TENNESSEE VALLEY AUTHORITY

Enclosed are responses to TVA action items resulting from the NRC's geotechnical audit of Watts Bar Nuclear Plant conducted September 22 through 24, 1982. This completes TVA action with the exception of the analysis of axial stresses on buried pipe which will be provided by March 5, 1983.

ENCLOSURE
WATTS BAR NUCLEAR PLANT UNITS 1 AND 2

NUCLEAR REGULATORY COMMISSION
AUDIT ON GEOTECHNICAL DESIGN FEATURES

Figure 1

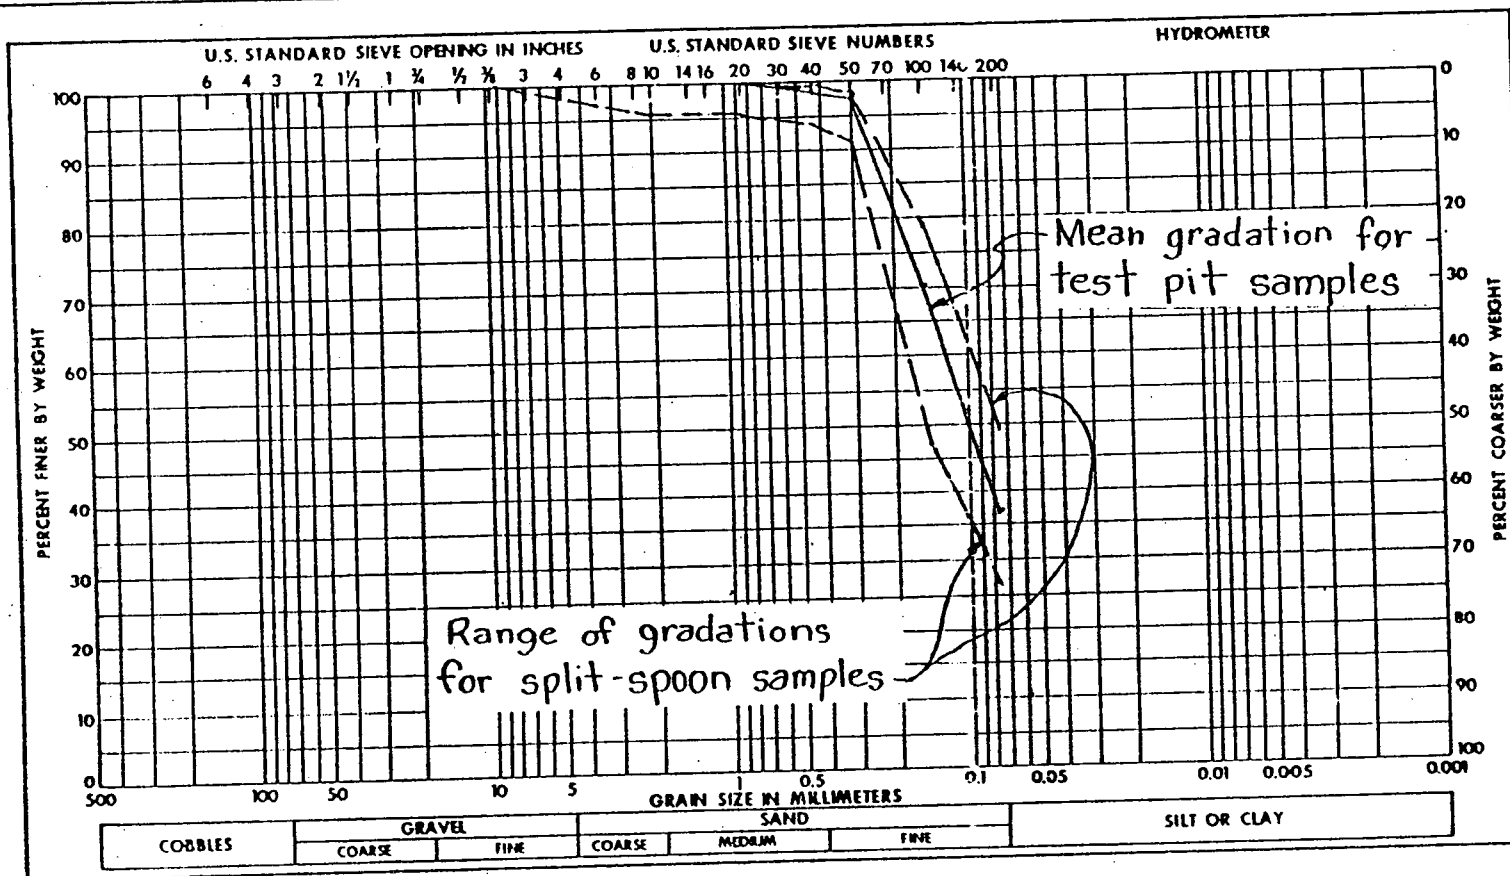
Provide the rationale used for concluding that the samples used in the cyclic testing are representative of actual field conditions.

Tables 1 and 2 are comparisons of the classification data for the samples from test pits 1 and 2, respectively with the classification data for SM soils from the split-spoon borings closest to each test pit respectively. Figure 1 is a plot of the gradation of the samples from test pit 1 compared with the range of gradations for the split-spoon samples given in table 1. Figure 2 is a plot of the gradation of the samples from test pit 2 compared with the range of gradations for the split-spoon samples given in table 2. The information contained in these tables and figures shows that the data on the undistributed block samples correlates very well with the data from the split-spoon borings nearest the test pits.

Remarks: Comparison of
Test Pit #1 samples with SM
samples from split-spoon
borings 134, 134A, & 135A
